ADDENDUM #1
ADA RESTROOM UPGRADES-SPARKS REC CENTER
BID #19/20-004 / PWP #WA-2020-052
BIDS DUE NO LATER THAN: 1:45 PM ON NOVEMBER 13, 2019
PUBLIC BID OPENING: 2:00 PM ON NOVEMBER 13, 2019

This addendum is to notify all potential proposers of clarifications made to the Bid documents as stated below.

Subway Tile

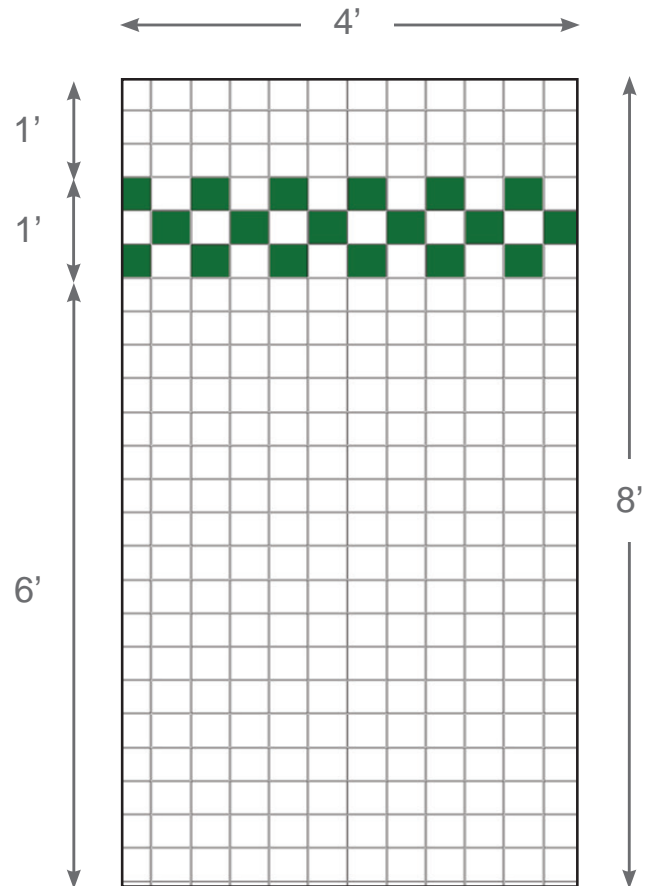
- b. "What is the technical specification for the FRP?"
 - i. The FRP shall be Marlite Symmtrix FRP Subway Tile SYM C 100-G63 White, or equal (See tech spec/cutsheet attachment).

C 100-G63 White
